DETROIT DIESEL

ATS Technician's Guide

NUMBER: 2-ATS-07 **S.M. REF.:** Listed in Table 1 **ENGINE:** ATS **DATE:** April 2007

SUBJECT: UPDATES TO AFTERTREATMENT SYSTEM TROUBLESHOOTING

Figure 1 DOC Outlet Temperature Sensor

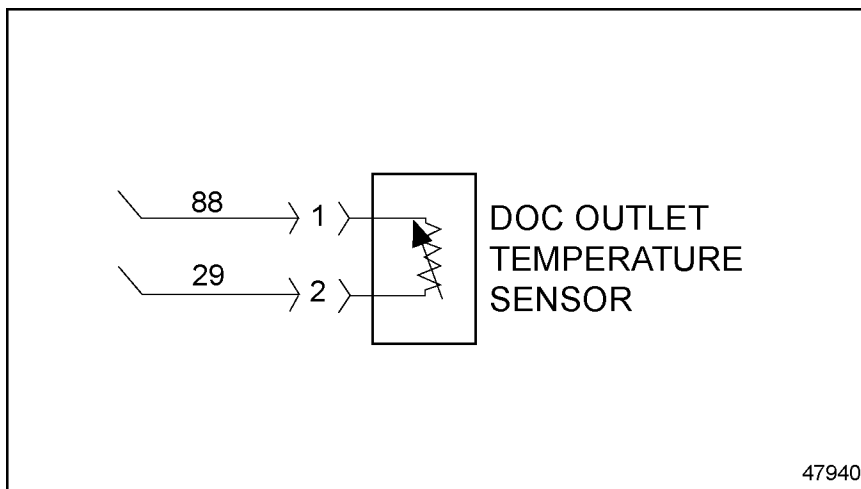
1. Disconnect DOC Inlet Temperature Sensor and inspect connector for damaged, bent, spread, or corroded pins. If the temperature sensor connector is OK, the connections upstream to the MCM (ATD harness 10-pin connector pin 6, 31-pin VIH connector pin 18 and the 120-pin MCM connector pin 89) must also be checked. See Figure 1.

- [a] If damage is found, repair connector(s) as necessary. Verify repairs.
- [b] If OK, replace DOC Inlet Temperature Sensor. Verify repairs.

Figure 2 DPF Outlet Temperature Sensor

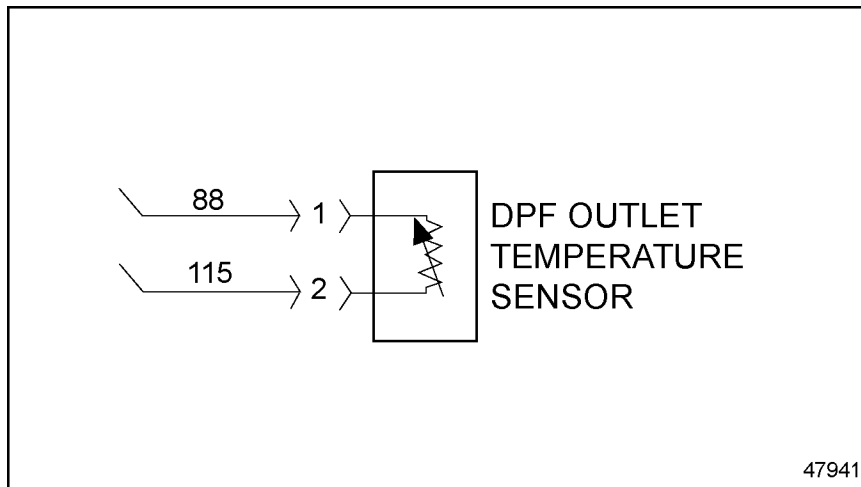
1. Turn ignition ON (key ON, engine OFF).
2. Monitor DPF Inlet and DPF Outlet Temperature.
 - [a] If the DPF Outlet Temperature 400°C (750°F) is greater than DOC Outlet Temperature, go to step 3.
 - [b] If the DPF Outlet Temperature 400°C (750°F) is less than DOC Outlet Temperature, go to step 5.
3. Turn ignition OFF.
4. Disconnect DPF Outlet Temperature Sensor and inspect connector for damaged, bent, spread, or corroded pins. If the temperature sensor connector is OK, the connections upstream to the MCM (ATD harness 10-pin connector pin 7, 31-pin VIH connector pin 19, and the 120-pin MCM connector pin 115) must also be checked, see Figure 2.

- [a] If found, repair connector as necessary. Verify repairs.
 - [b] If OK, replace DPF Outlet Temperature Sensor. Verify repairs.
5. Remove Aftertreatment Device.

Figure 3 DPF Inlet Pressure Sensor

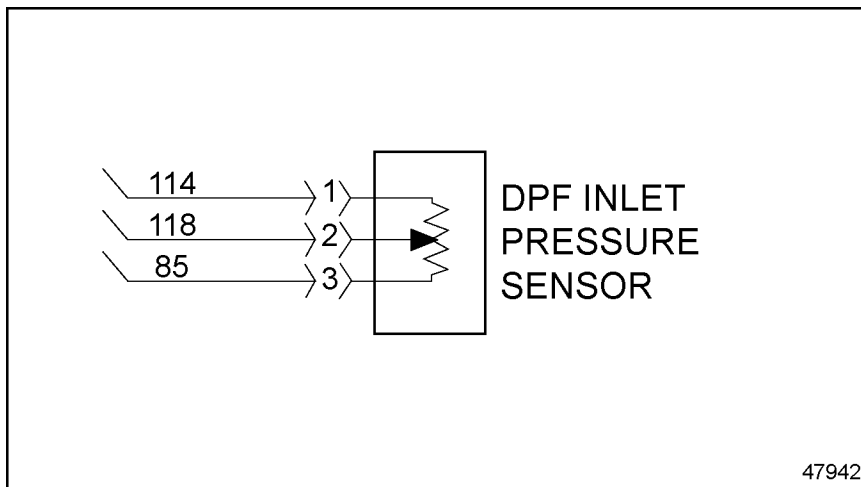
1. Turn ignition ON (key ON, engine OFF)
2. Check for multiple codes.
 - [a] If 3609/3 and 3610/3, are present, go to step 3.
 - [b] If only 3609/3 is present, go to step 5.
3. Disconnect the DPF Inlet Pressure Sensor.
4. Measure the voltage between pin 1 of the DPF Inlet Pressure Sensor and ground (battery ground lug by starter).
 - [a] If the voltage is present, repair the short to power between pin 114 of the 120-pin MCM connector and the DPF Inlet and DPF Outlet pressure sensors. Verify repairs.
 - [b] If no voltage is present on pin 1 of the DPF Inlet Pressure Sensor, repair the open between pin 114 of the 120-pin MCM connector and DPF Inlet, pin 1 and DPF Outlet, pin 1 pressure sensors. Verify repairs.
5. Disconnect DPF Inlet Pressure Sensor connector. See Figure 3.

-
6. Turn the ignition switch to the OFF position.
 7. Disconnect the 120-pin MCM connector.
 8. Measure the resistance across pins 2 and 3 of the DPF Inlet Pressure Sensor connector.
 - [a] If the resistance is less than 5 Ω , repair the short between the 120-pin MCM connector wires 85 and 118. Verify repairs.
 - [b] If the resistance is greater than 5 Ω , repair short to power on circuit between the 120-pin MCM connector pin 118 and the DPF Inlet Pressure Sensor connector pin 2. Verify repairs.

Figure 4 DPF Outlet Pressure Sensor

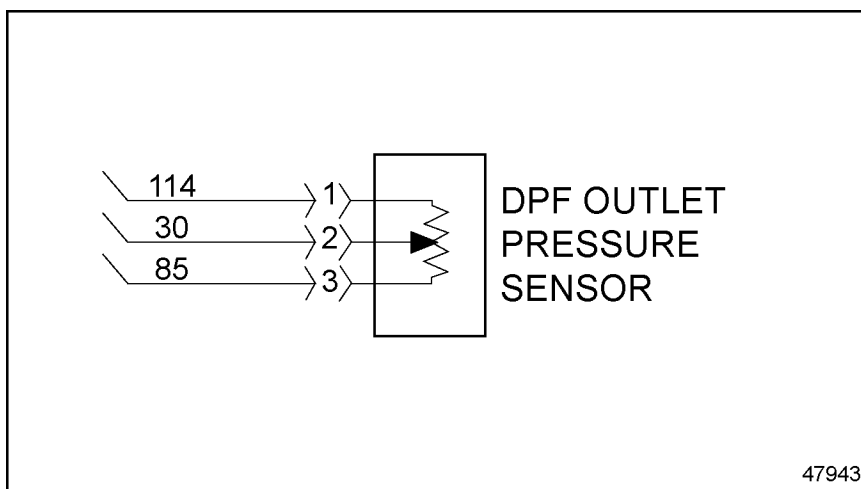
1. Turn ignition ON (key ON, engine OFF).
2. Check for multiple codes.
 - [a] If 3610/3 and 3609/3 are present, go to step 3.
 - [b] If only 3610/3 is present, go to step 5.
3. Disconnect the DPF Outlet Pressure Sensor.
4. Measure the voltage between pin 1 of the DPF Outlet Pressure Sensor and ground (battery ground lug by starter).
 - [a] If the voltage is greater than 2.75 volts, repair the short to power between pin 114 of the 120-pin MCM connector and the DPF Inlet and DPF Outlet pressure sensors. Verify repairs.
 - [b] If no voltage is present on pin 1 of the DPF Outlet Pressure Sensor, repair the open between pin 114 of the 120-pin MCM connector and DPF Inlet and DPF Outlet pressure sensors. Verify repairs.
5. Disconnect DPF Outlet Pressure Sensor connector. See Figure 4.

6. Turn the ignition switch to the OFF position.
7. Disconnect the 120-pin MCM connector.
8. Measure the resistance across pins 2 and 3 of the DPF Outlet Pressure Sensor connector.
 - [a] If the resistance is less than 5 Ω , repair the short between the 120-pin MCM connector wires 30 and 85. Verify repairs.
 - [b] If the resistance is greater than 5 Ω , repair short to power on circuit between the 120-pin MCM connector pin 30 and the DPF Outlet Pressure Sensor connector pin 2. Verify repairs.
